**PROPOSED FRONT ELEVATION
(REGENT ST)**
1 : 50

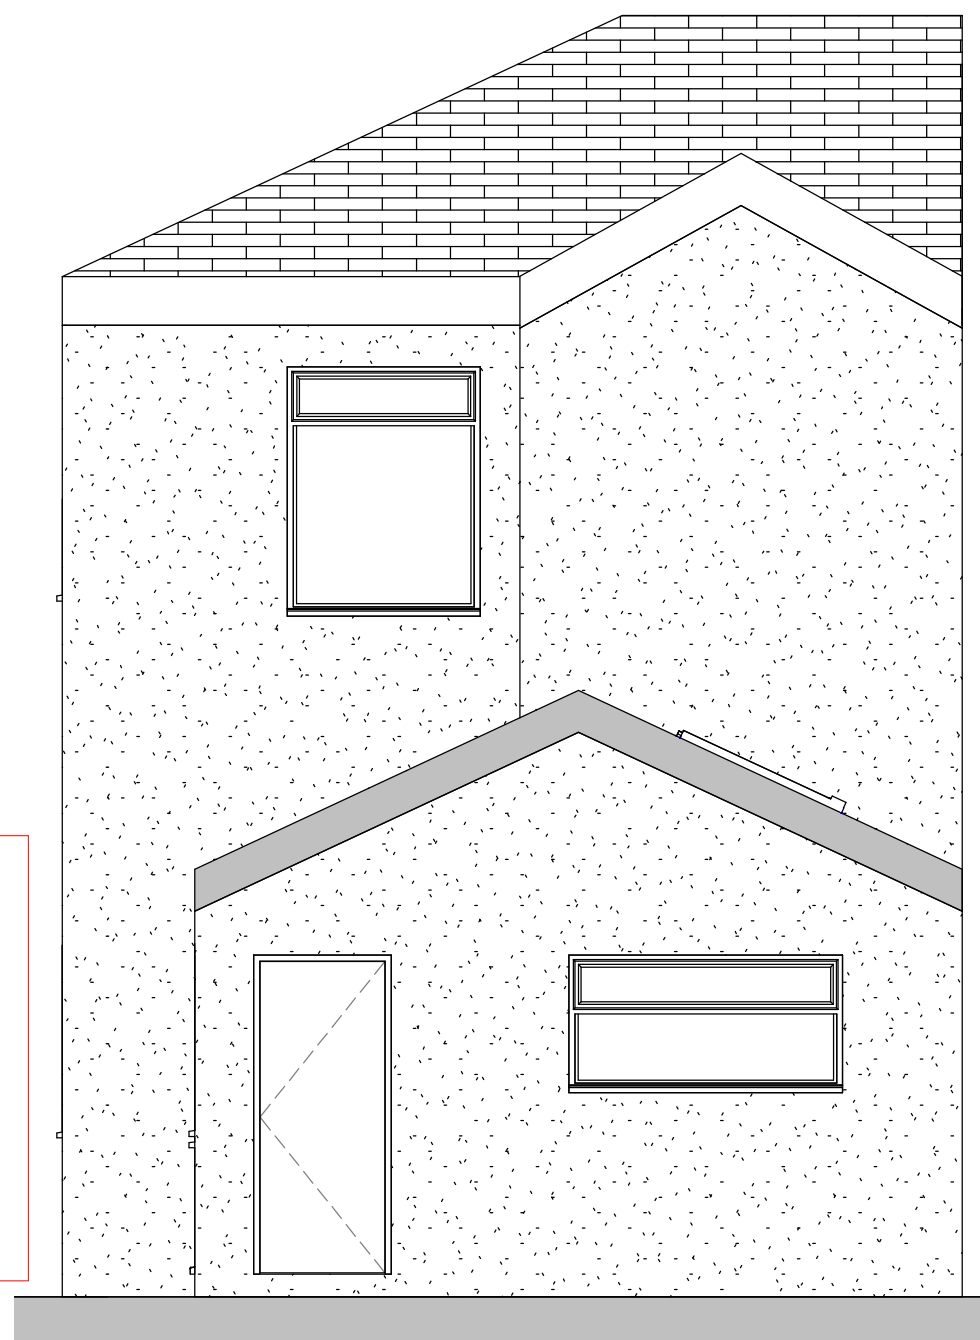
3. In response to concerns about the variety of roof forms and materials, we have simplified the design to incorporate a sloped roof. This uniform roof design complements the existing dwelling and aligns with the architectural character of the area. The gable end of the new extension matches the shape of the existing roof above

PROPOSED SIDE ELEVATION 1 (HIGH ST)
1 : 50

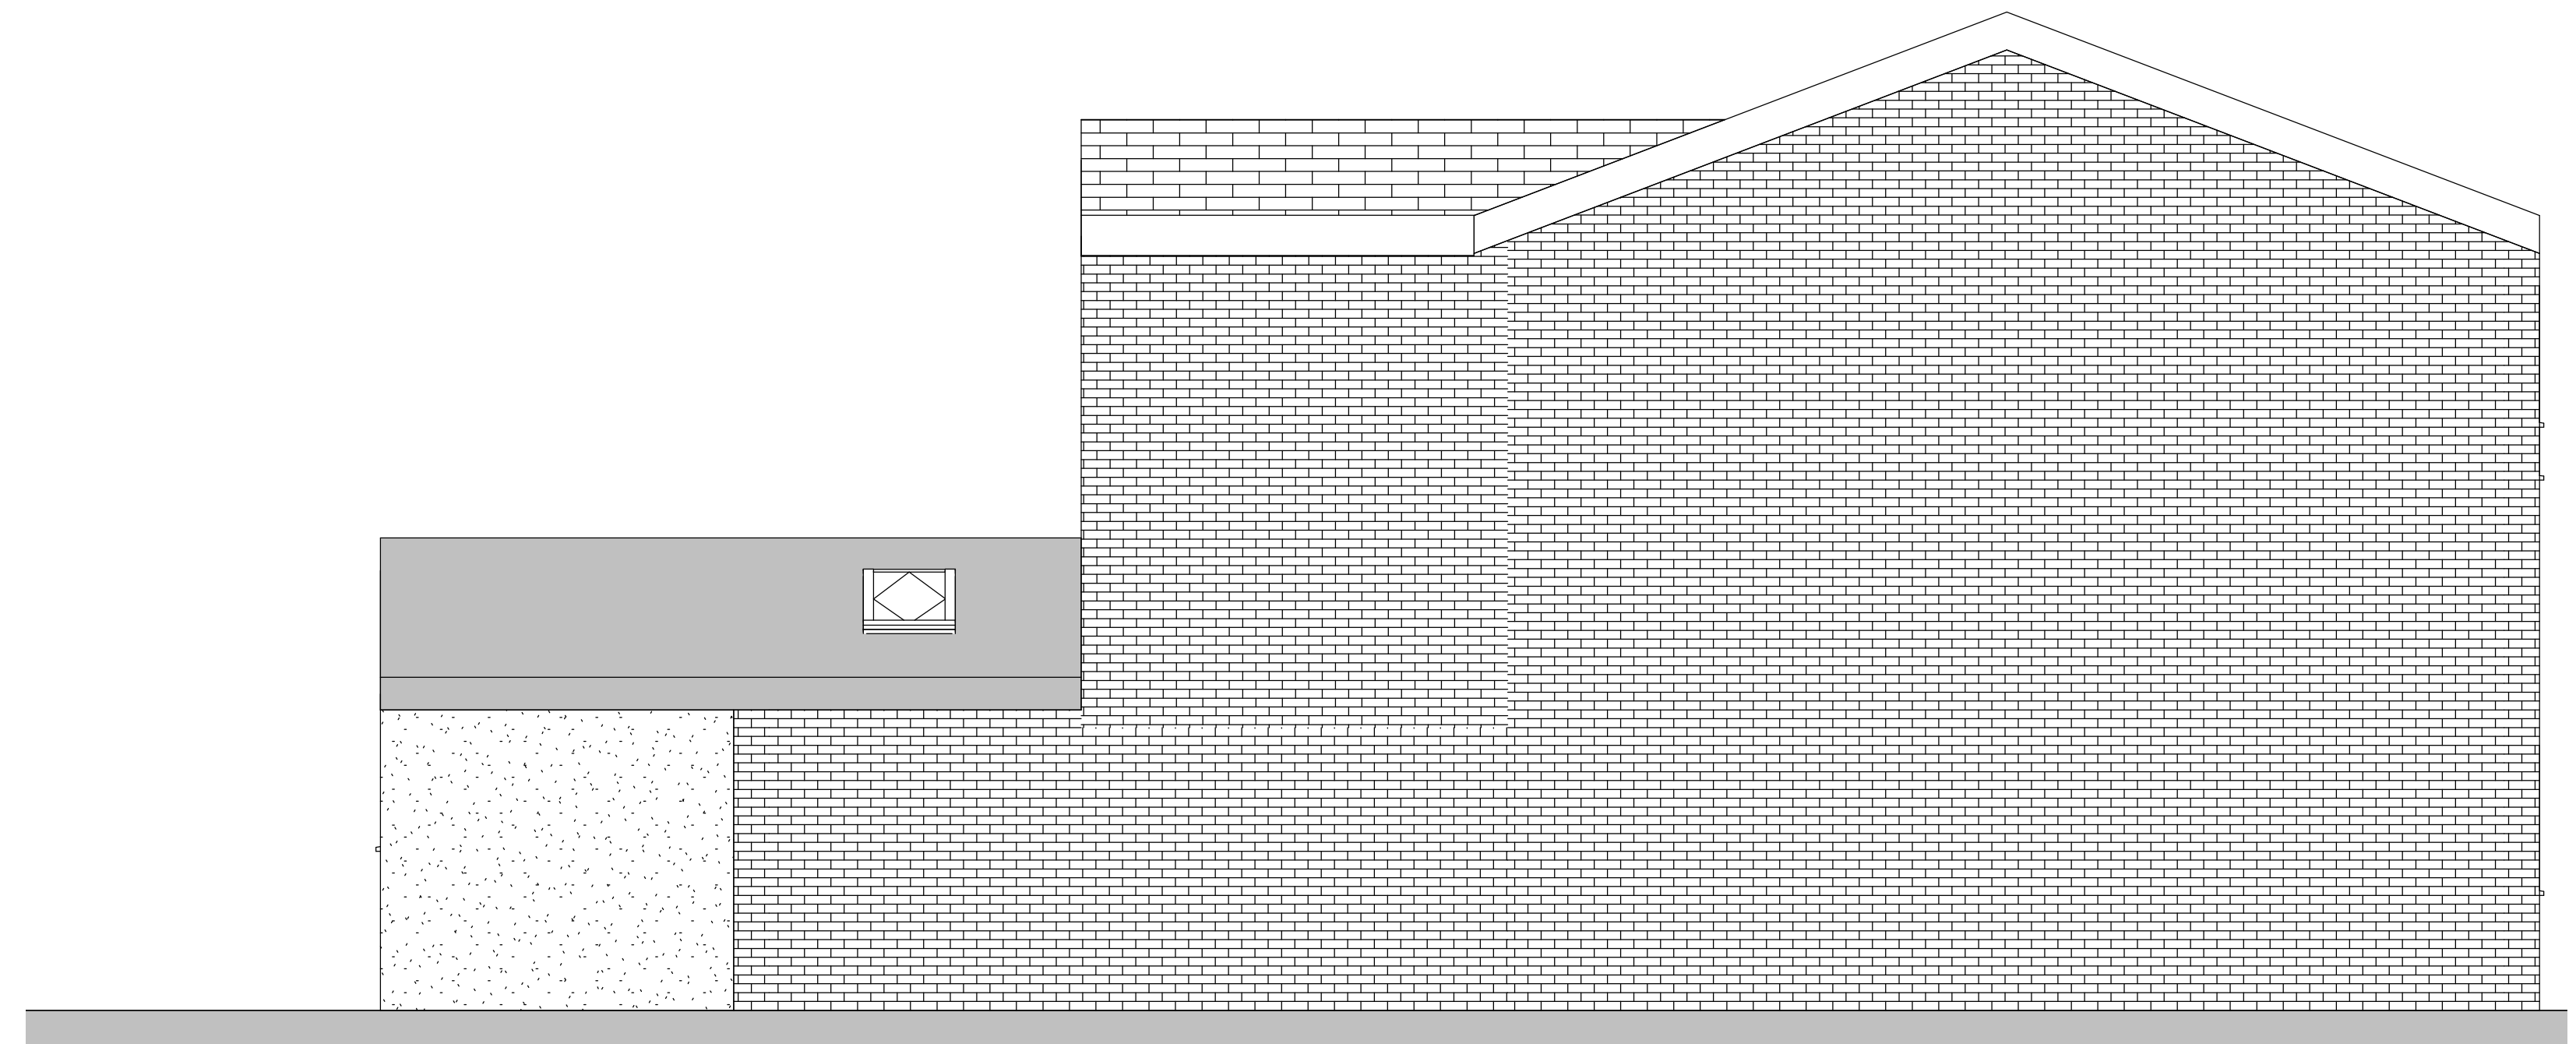
2. We have also reduced the overall height of the extension from 2.9 metres to 2.8 metres. This new height is more in line with permitted development standards and ensures the extension is not unduly visible above the boundary treatment. The reduction in height further minimises any potential visual impact on neighbouring properties, ensuring a harmonious relationship with the surrounding built environment.
